1822 Bank Street

URBAN DESIGN BRIEF

OCTOBER 11, 2024

RESPONSE TO URBAN DESIGN COMMENTS

VIEW FROM ABOVE NORTHWEST SHOWING 45 DEGREE ANGULAR PLANE

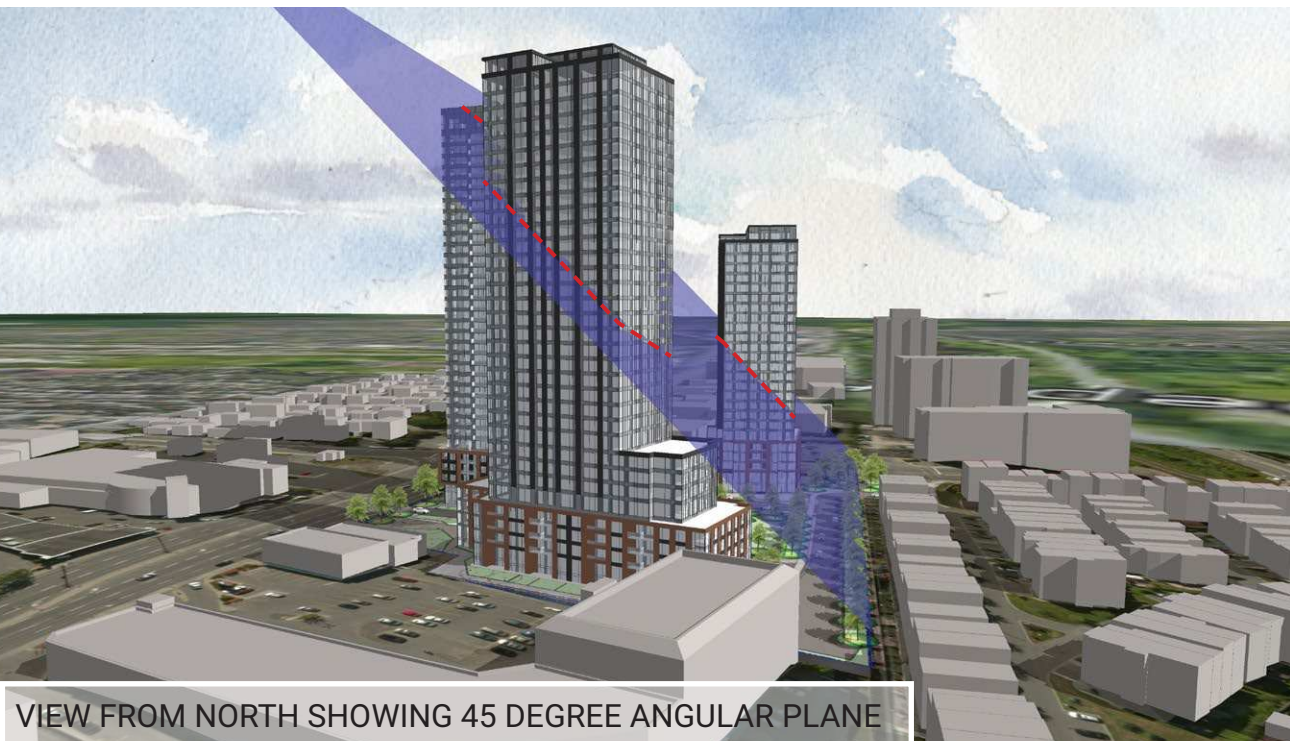
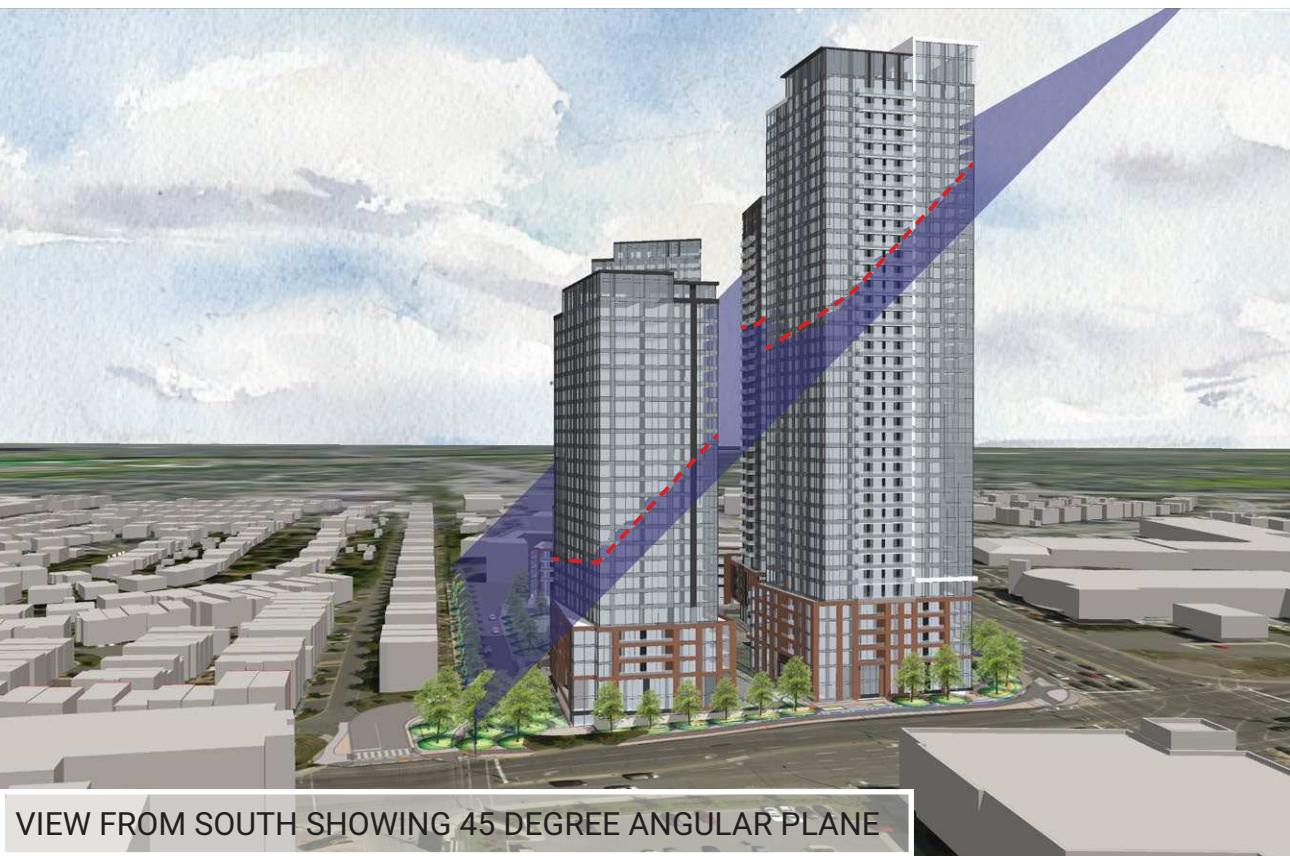
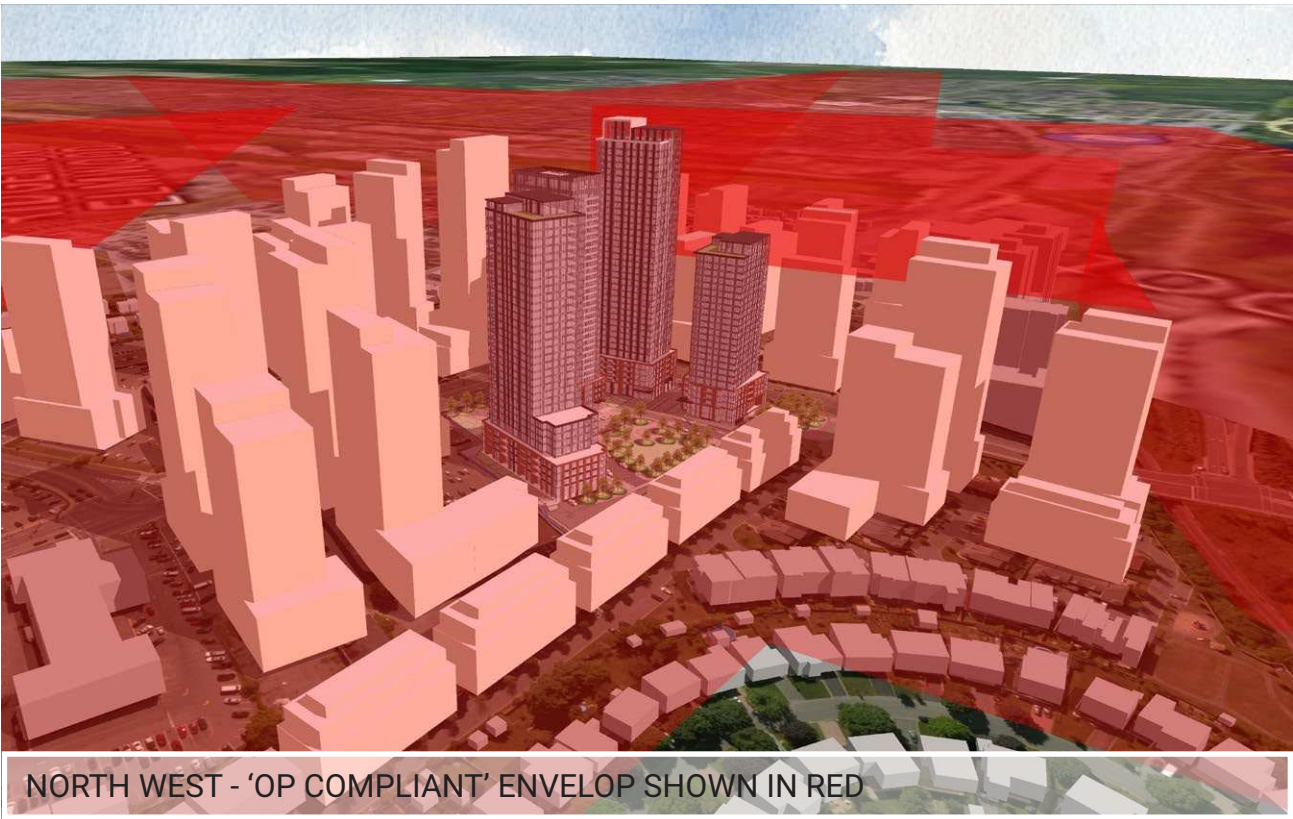
41. Ensure effective built form transition, guided by the application of angular planes.

Applicant: Please refer to the angular plane diagrams included in the UDRP submission set. We feel that the proximity to the transit station and future development potential under the OP justifies some elements of the development breaking the 45 degree angular planes. The trade-off the proposed development offers is providing the majority of the western edge as greenspace. This minimizes the number of the existing townhomes impacted by overlook / shadowing.
